Date:		1/2/08	<u>.</u>	
Permit Number:		B080059		•
Project Description:	,	NEW HOLDIE	But ATM/NIGHT	- Dan Rosa
Owner:	,	Wachovia	Bank.	CATRO
Architect and/or Engineering	Firm:		Avichitects	-
Name of Architect or Enginee	r of Record:		chemendia	-
Address of Architect / Engine	,		Way, Smite 503 Miam	È Et Briar
Contact Number:	3	305.858.		1, TO 23144
Part One: Architect / Eng Lourdes Echemend	A LOV	ntt kalen mitte sitte fra en også er en skærerske en i de skærerske en de skæftande	ericke menenderite foor bedoekkennemgenere oper, klakkenser megt helde daar ensek van valgegen giv v	· ·
LEMENTS AVEILTECTS	as the Architect /	Engineer of Recor	d for the project covered under the	
, , ,	···• ······• · · · · · · · · · · · · ·		, ,	
Total Gross Floor Area of New Total Gross Floor Area of Alte	Construction:			-
 Single Family Homes, Dup 	lexes, and Areas within			
Recidential Conda wait	, which is the control of the		<u> </u>

RESPONSE TO COMMENTS

City of Miami Beach, Wachovia – Alton Road Response to Building Dept. Cmts. Page 2 of 4

ELECTRICAL
PARTIAL FLOOR PLAN
SCALE: 1/4"=1'-0"

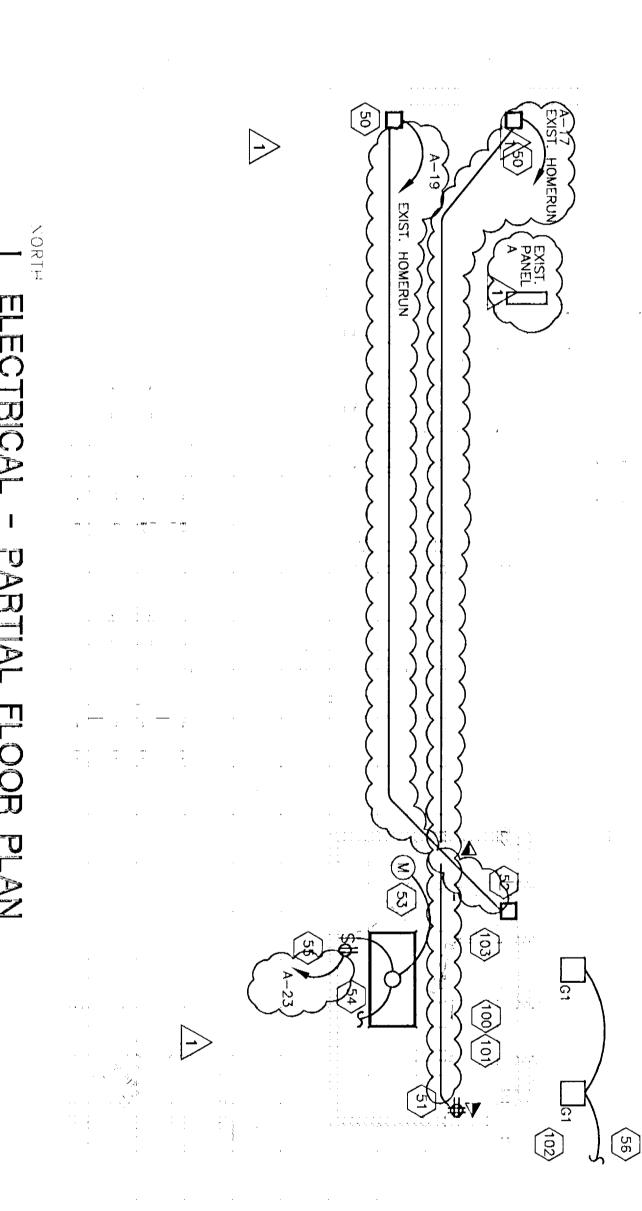
Comment 2: Circuit numbers and existing load on circuits as well as load to

Comment 3: Conductor size.

Response: The circuit numbers and loads have been added to the

drawings. See revised notes on Drawing E0.1, dated Revision 1, 12/12/07. See Revised Floor Plan on Drawing E1.0, dated

Response: The new conductor sizes have been indicated on Panel "A".

See Drawing E1.0, dated Revision 1, 12/12/07.

ATM ELEVATION SCALE: NTS

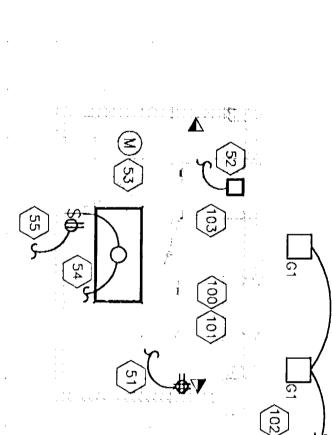
Show ATM reachable ranges.

Refer to revised Sheet A5.1 for the elevation of both the ATM and AHD equipment with the applicable heights.
